September 20, 2022

**RE: LU-22-61 – Response to TAC Comments
77 Meredith Way – Randi & Jeff Collins – Tax Map 162 Lot 16
TFM Project #47442-00**

TAC REVIEW COMMENTS:

TAX MAP 162 LOT 16
SITE PREPARATION & DEMOLITION PLAN
PROPOSED 2 LOT SUBDIVISION
77 MEREDITH WAY

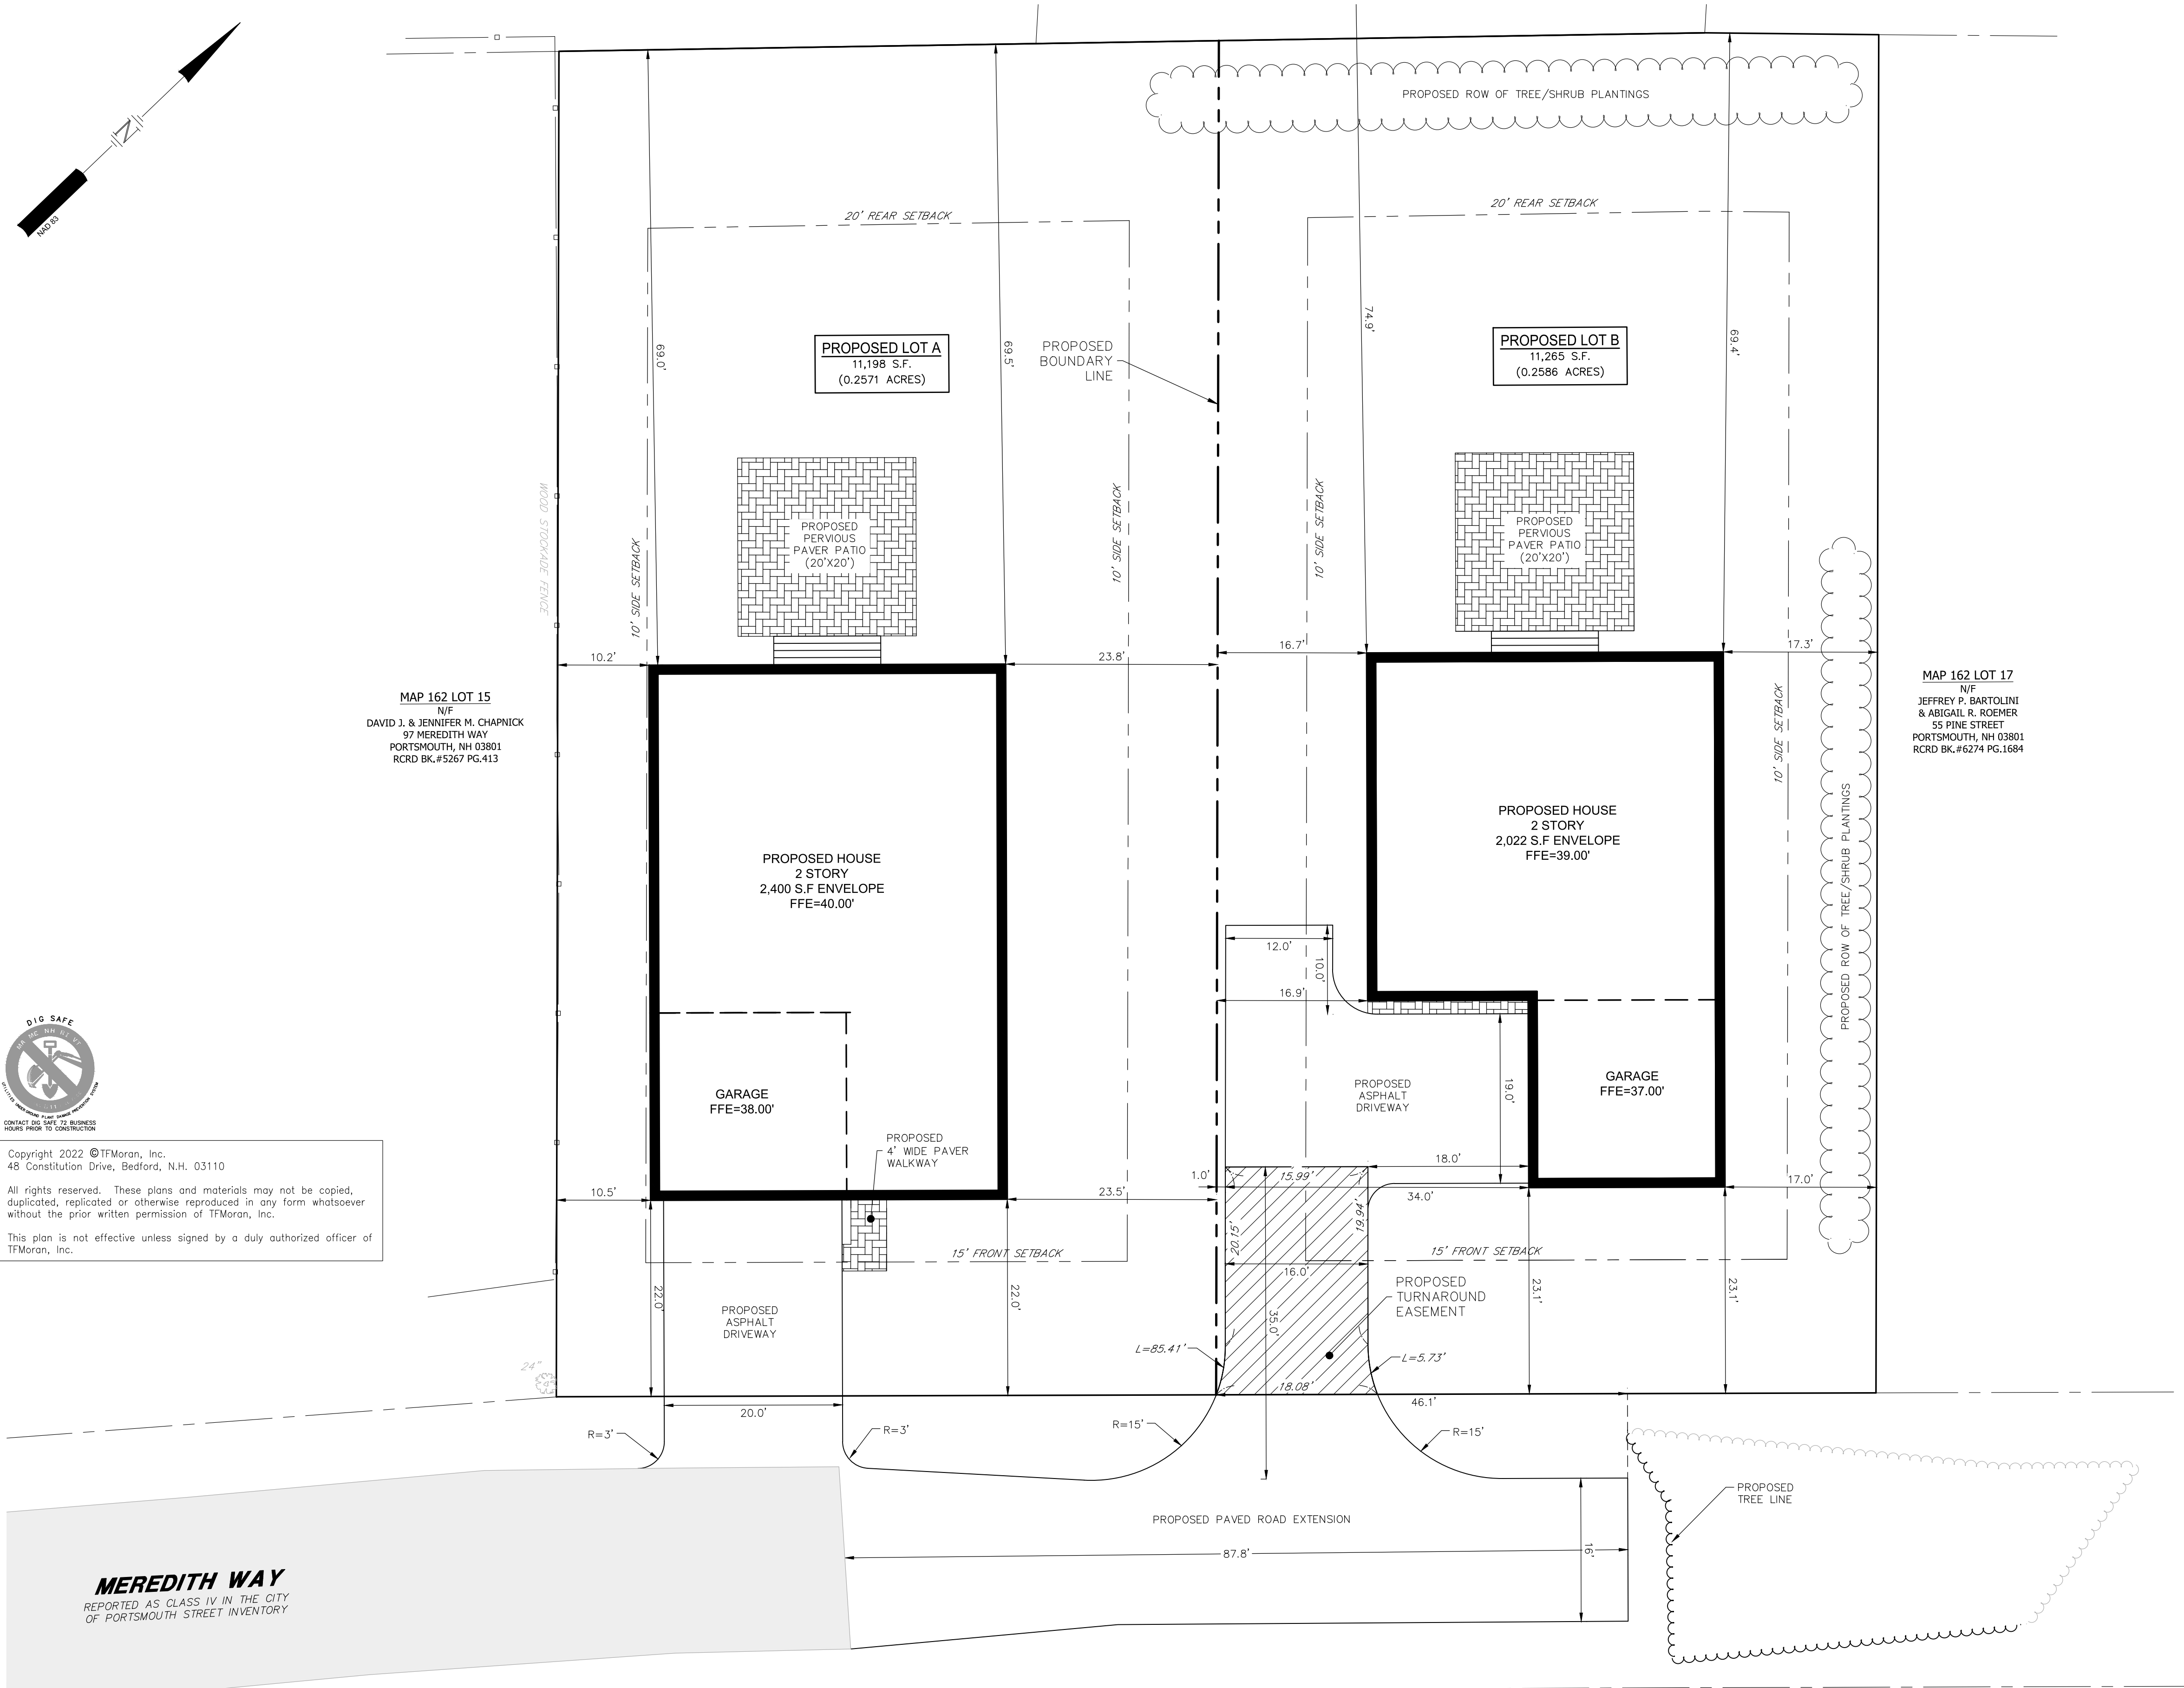
1. The existing sewer line for #77 is to be cut and capped at the main in Pine St.

2. The existing water line is to be cut and capped at the main in Meredith Way, the rest of the service should be abandoned, not removed.

Revised, see inset on Sheet C-02.

Revised, see label on Sheet C-02.

SITE LAYOUT PLAN PROPOSED 2 LOT SUBDIVISION 77 MEREDITH WAY

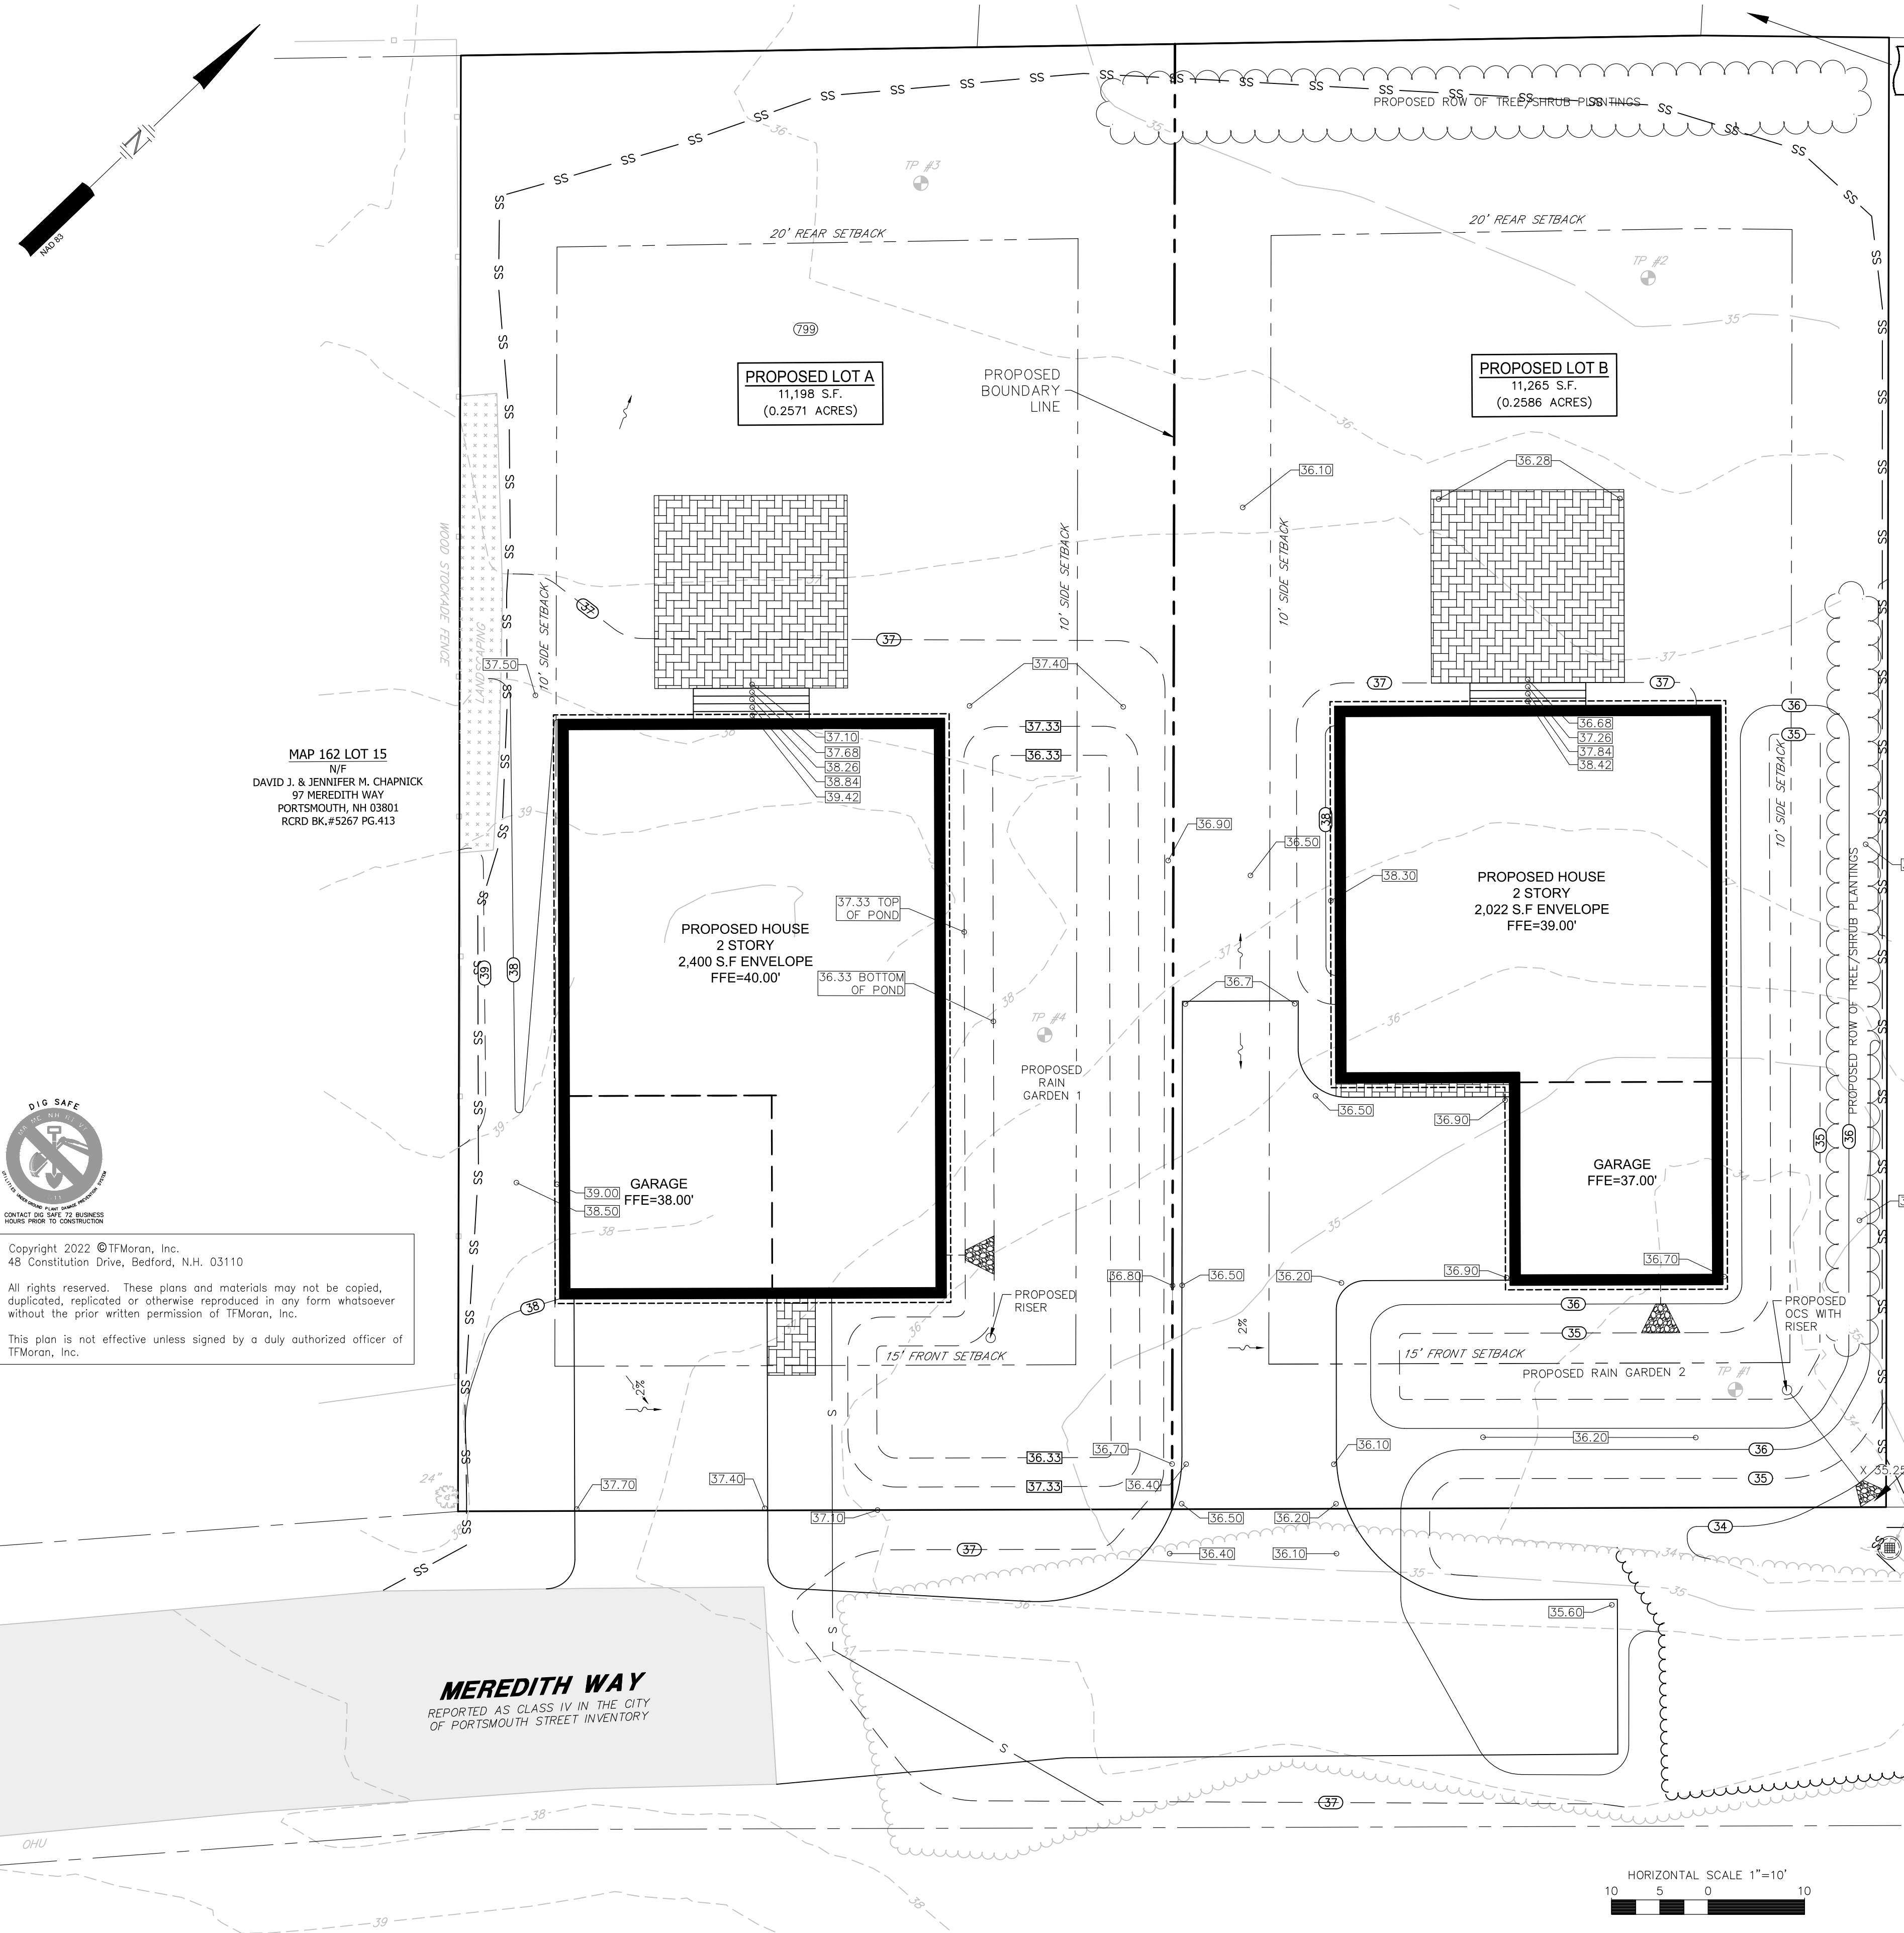
3. The driveway to lot ‘B’ should be at least a foot off of the side property line.

4. The roadway needs to be extended at least to the center of the garage proposed for Lot 'B' as previously stated. As shown that road is not long enough for our truck to actually turn around as the truck is almost 28' long.

5. The patios in the rear yards are to be porous so they do not encourage runoff.

Revised, see Sheet C-03.

Revised, see Sheet C-03.

Revised, see Sheet C-03 & detail on Sheet C-08.

RAIN GARDEN TYPICAL SECTION

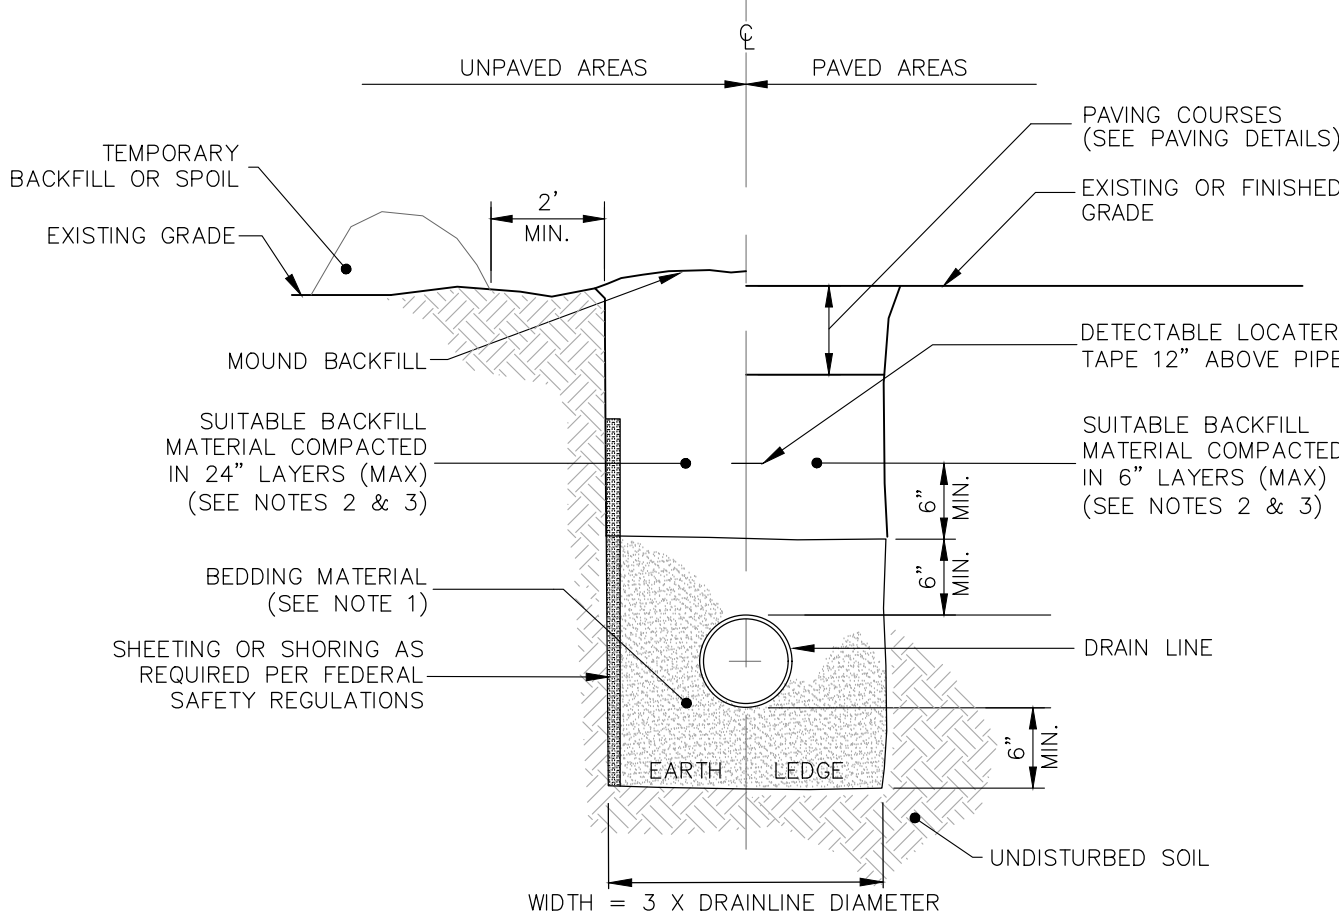
15. Provide calculations for the rain garden footprint sizing based on the perc rate of the existing soil. Provide enough open voids in the stone above the ESHWT for at least 1" of rain. Make sure to specify removal of any clay or restrictive soils down to the bottom of the pond.

Enough room is provided within stone for 1" rain, see Sheet C-04. 1" rain event printouts are in the provided Drainage Summary.
